**REVIEW OF WELL TESTING AND
SUSTAINABLE YIELD ASSESSMENT**

**PROPOSED LAETITIA AGRICULTURAL
CLUSTER SUBDIVISION
SAN LUIS OBISPO, CALIFORNIA**

October 2011

Figure
11

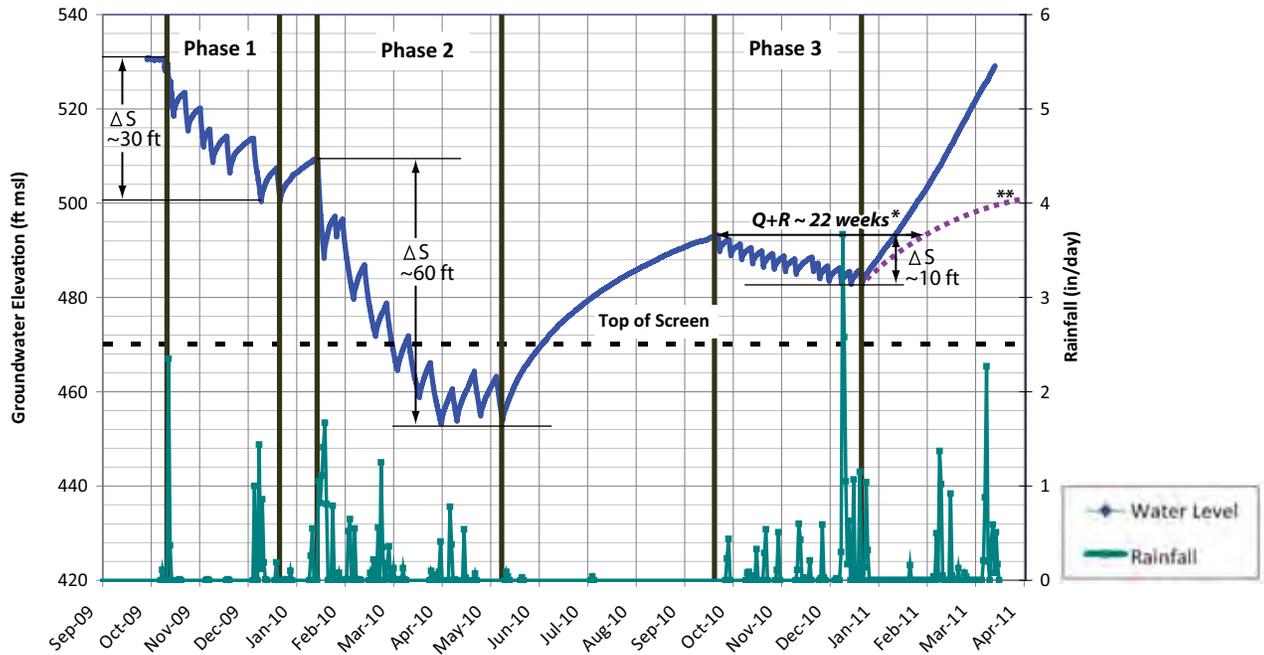
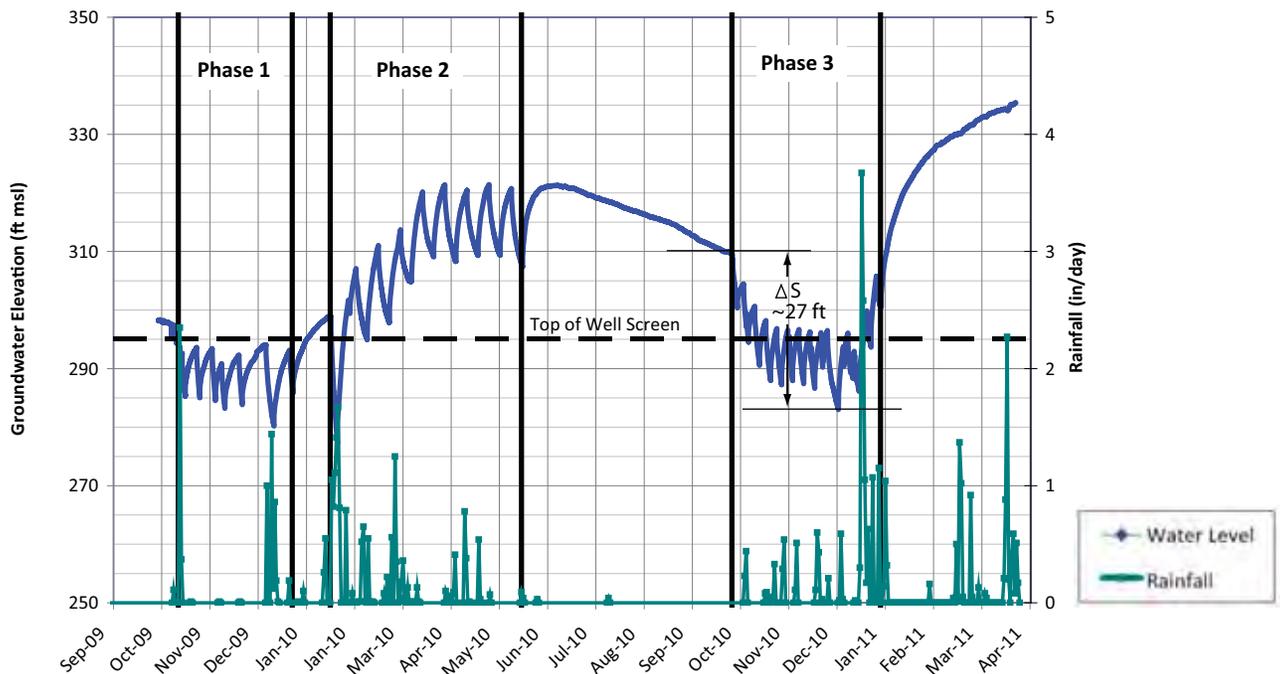
In Well 10, recovery of water level was incomplete after Phase 1 and Phase 2 testing, but a rapid rise in water level occurred after the Phase 3 pumping, which is attributed to period of abundant rainfall (Figure 11). The recovery of water level in Well 10 after Phase 2 pumping is considered more typical.

The “equilibrium discharge rate” (Q_{eq}) approach used by CHG (July 2010) for the Phase 1 and 2 data was also used to calculate revised estimates of “equilibrium interval” sustainable pumping rates by accounting for the time for groundwater levels to recover to pre-Phase 3 “operational static” elevations and scaling the Phase 3 pumping rates accordingly. The Phase 3 pumping and recovery periods and the “equilibrium interval” pumping rate calculation are shown with the hydrographs in Figures 11 and 12.

* Phase 3 $Q_{eq} = (2.75 \text{ AF}/22 \text{ wks})(52 \text{ wks}/\text{yr}) = 6.5 \text{ AF}/\text{Y} = 4.0 \text{ gpm}$

** The rapid rise in water level in Well 10 after Phase 3 pumping appears related to period of abundant rainfall. Recovery after Phase 2 pumping is likely more typical. Accordingly, the sketched recovery curve after the Phase 3 pumping was used for the equilibrium pumping calculation instead of the rapid recovery.

* Q_{eq} not calculated for Well 11 because the prominent recharge that occurs at this well is independent of pumping and complicates interpretation of the aquifer response to pumping.

Figure
12

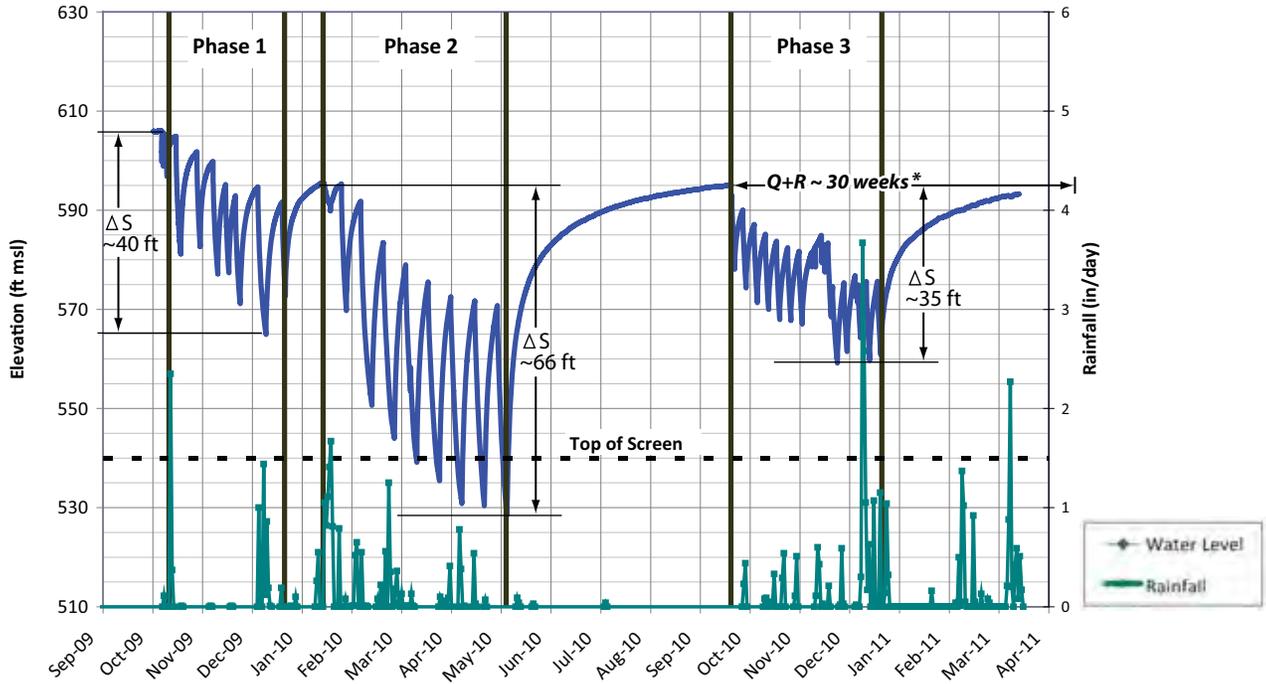
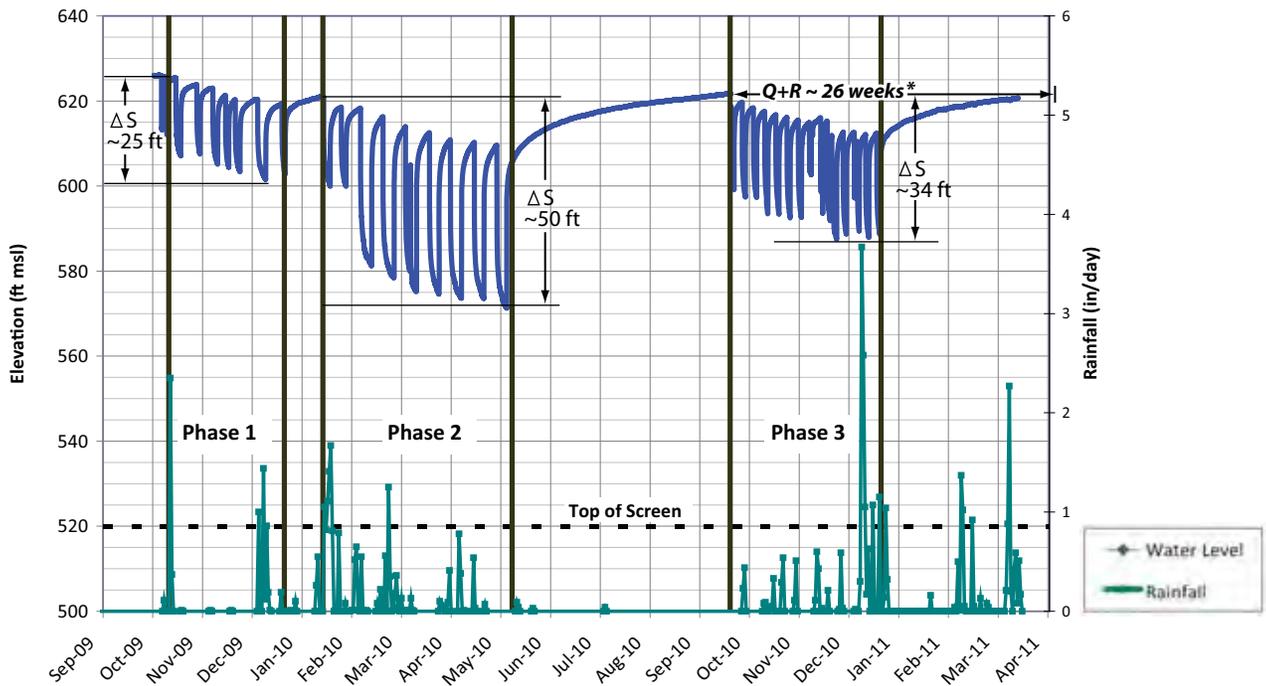
* Phase 3 $Q_{eq} = (5.23 \text{ AF}/30 \text{ wks})(52 \text{ wks}/\text{yr}) = 9.1 \text{ AF}/\text{Y} = 5.6 \text{ gpm}$

* Phase 3 $Q_{eq} = (5.48 \text{ AF}/26 \text{ wks})(52 \text{ wks}/\text{yr}) = 11.0 \text{ AF}/\text{Y} = 6.8 \text{ gpm}$

Figure
16

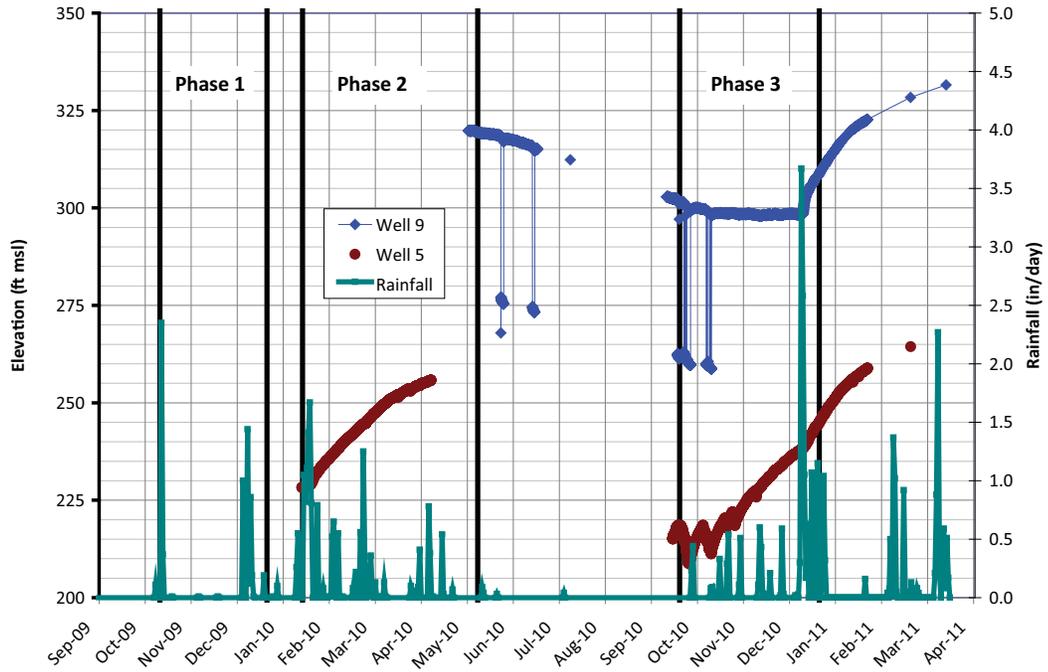
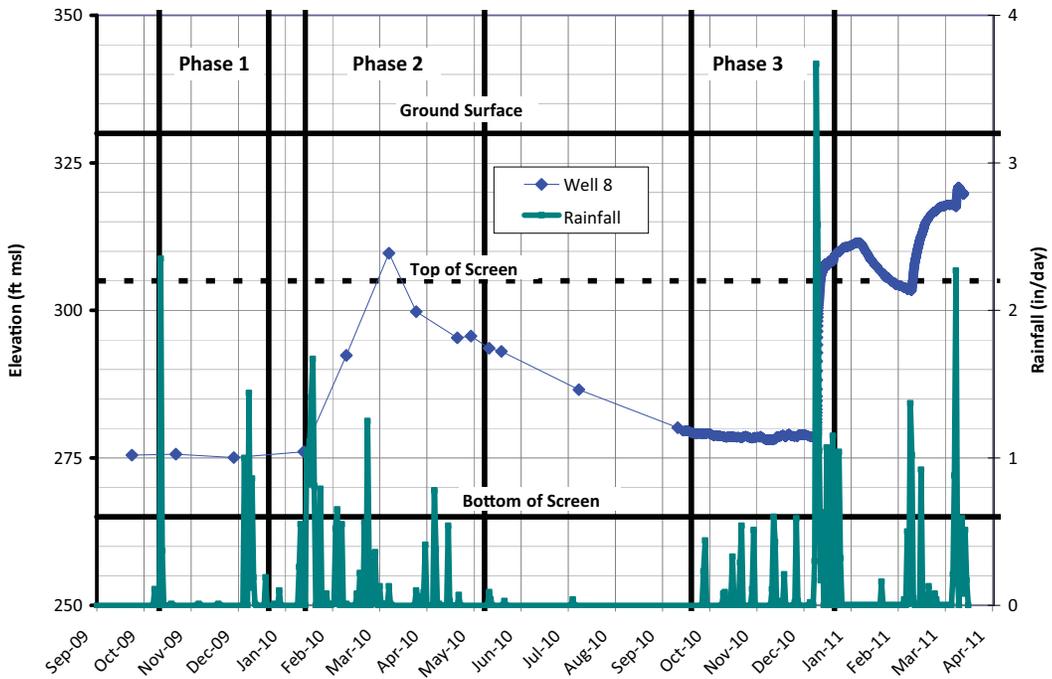
The hydrograph for Well 8 (Figure 16), which is completed in shallow alluvium along Los Berros Creek, shows a rapid 30-foot increase in water level in response to abundant rainfall in December 2010 and January 2011.

Although there are discontinuous water level records and there is uncertainty about pumping limit interpretation, the hydrographs for Wells 5 and 9 (Figure 16), which are completed in the Obispo Tuff, also show increases in water level following periods of abundant rainfall. Water level rise is particularly evident in Well 9 in response to the heavy rainfall in December 2010 and January 2011.

Figure
19

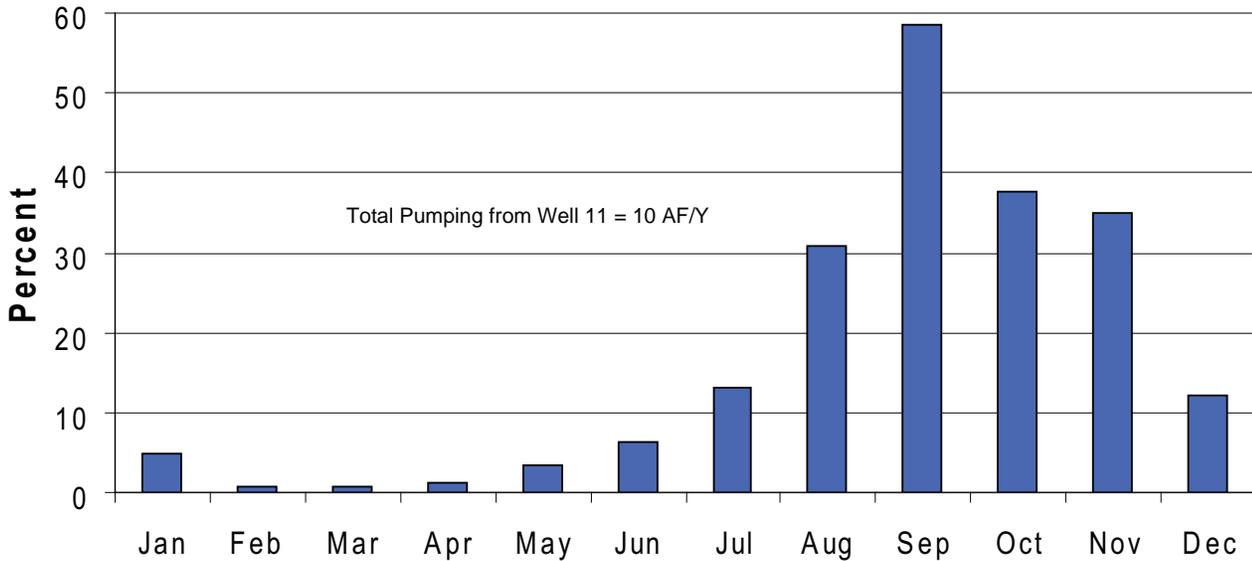
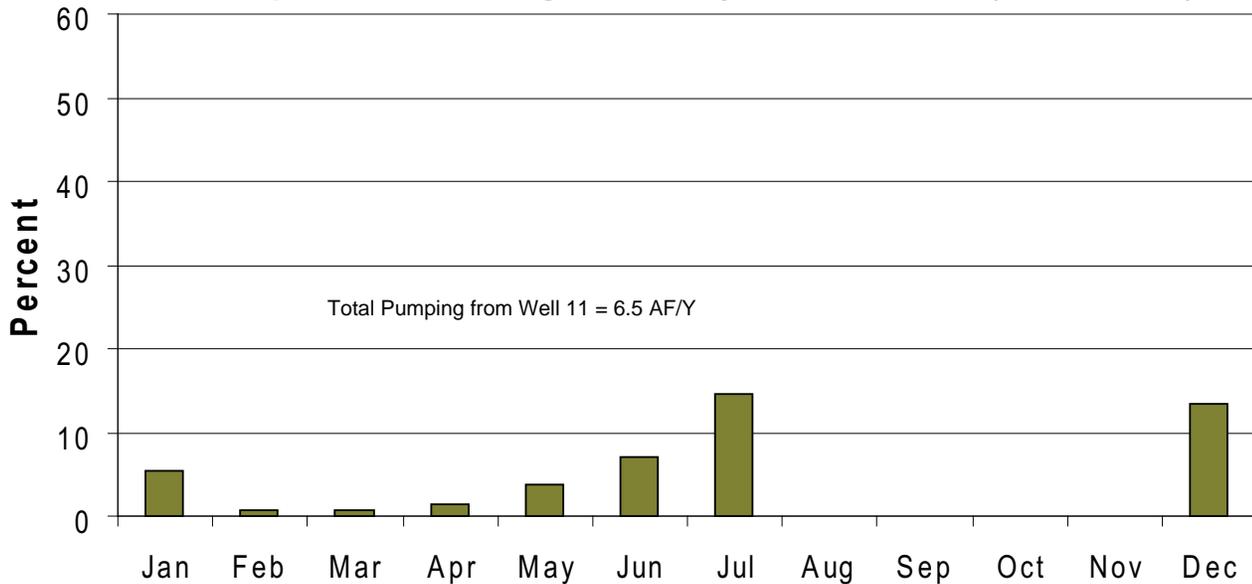
Although the production capacity of Well 11 was substantially higher than the other wells, the rapid recharge response, close proximity to the creek, and dropping water level beginning in June even without pumping indicates that the production capacity of Well 11 is dependent on base flow in Los Berros Creek and will likely decrease during summer and drought conditions. Moreover, pumping from Well 11 during late summer and autumn would likely substantially reduce base flow in the Los Berros Creek channel. Figure 19a shows the pumping rate proposed by CHG (July 2010) for Well 11 (38.2 AF/Y = 23.7 gpm) compared to average monthly flow rate in Los Berros Creek based on available data for the period from 1981 to 2001. During the months of August through November, the proposed pumping rate from Well 11 exceeds 30 percent of the average flow in Los Berros Creek.

Table 4 provides our revised estimates of viable long-term flow rates from the four wells with a net 26 percent reduction of pumping from Well 11 (relative to the Phase 3 rate) to lessen impact to Los Berros Creek (no pumping from August to November), and a 25 percent increase all year from Well 15 (relative to the revised rate scaled to the Phase 3 recovery). The revised resulting total production rate is 62.4 AF/Y or 38.7 gpm. This is a 28 percent decrease compared to the sustainable rate estimated by CHG (July 2010) on which the Phase 3 testing was based, but 135 percent of the allocated project demand of 46.3 AF/Y.
